REPORT TO THE
NUCLEAR REGULATORY COMMISSION

THE PACIFIC GAS AND ELECTRIC COMPANY

NUREG-0578:

"TMI-2 LESSONS LEARNED TASK FORCE
STATUS REPORT AND
SHORT-TERM RECOMMENDATIONS"

FIGURE 7.3-8
LOGIC DIAGRAM
AUXILIARY FEEDWATER PUMPS

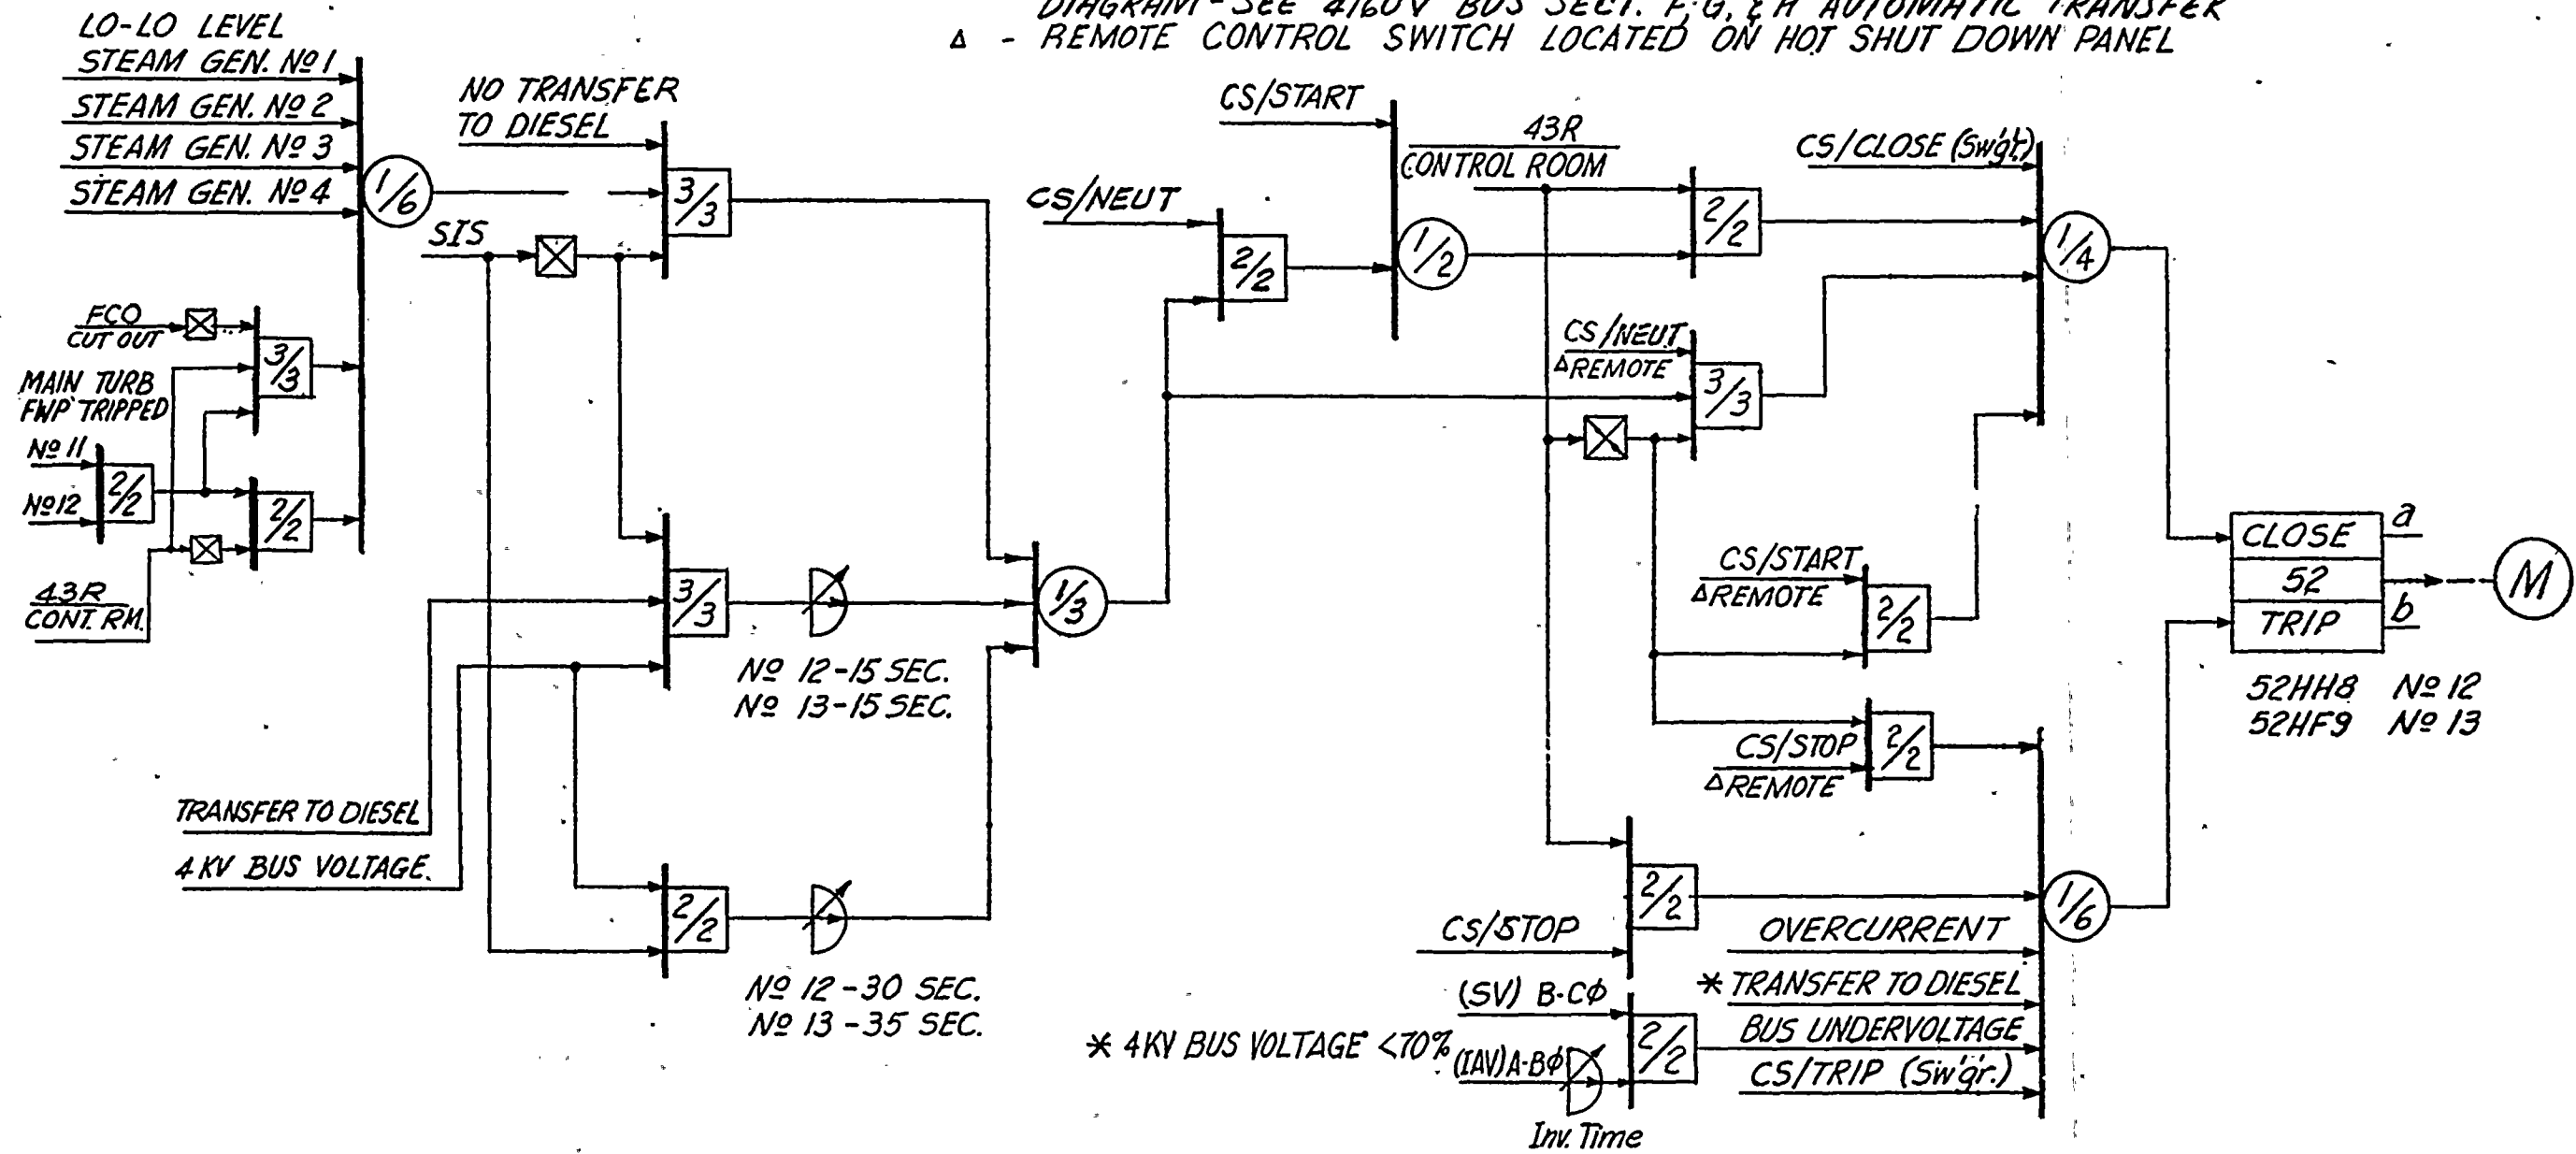
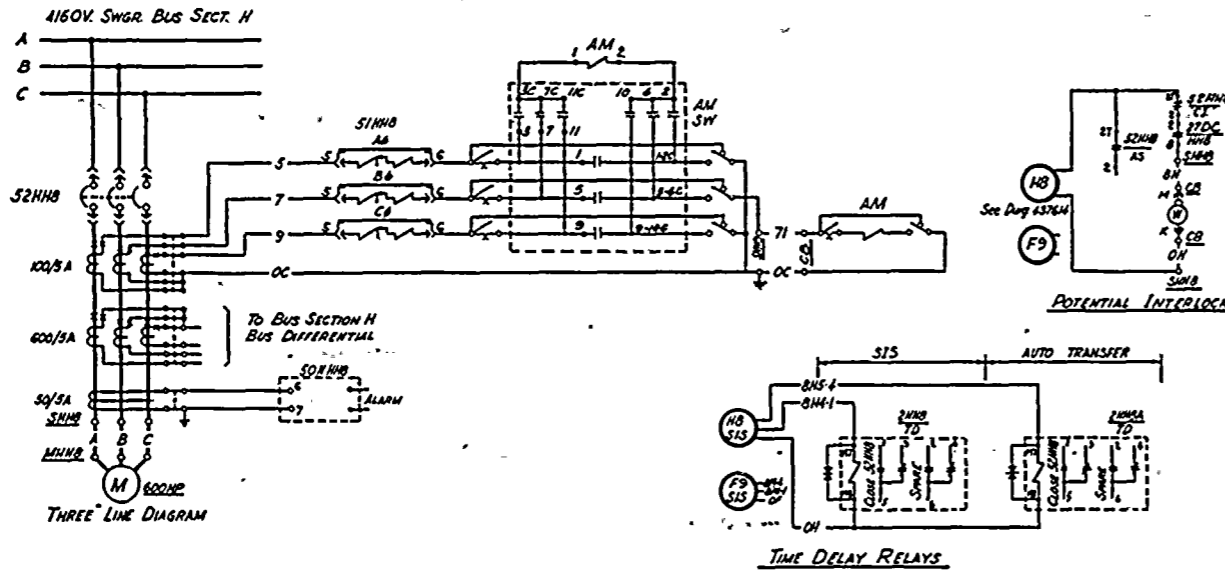
The design shall provide for the automatic initiation of the auxiliary feedwater system.

The auxiliary feedwater system is shown in the attached FSAR Figure 3.2-03, Sheet 2 of 4. The pumps are automatically started by low-low steam generator level, feedwater pump trip, safety injection, or station blackout. See attached FSAR Figures 7.3-8, 7.3-17, and 7.3-18. As shown on FSAR Figure 7.3-17, the motor-driven auxiliary feedwater pumps are started by closure of the Solid State Protection System (SSPS) output relay K633. Relay K633 is actuated by safety injection initiation or low-low level in any steam generator. Each pump is started by a separate relay from redundant SSPS trains A and B. The motor-driven pumps are also automatically started by trip of both main feedwater pumps.
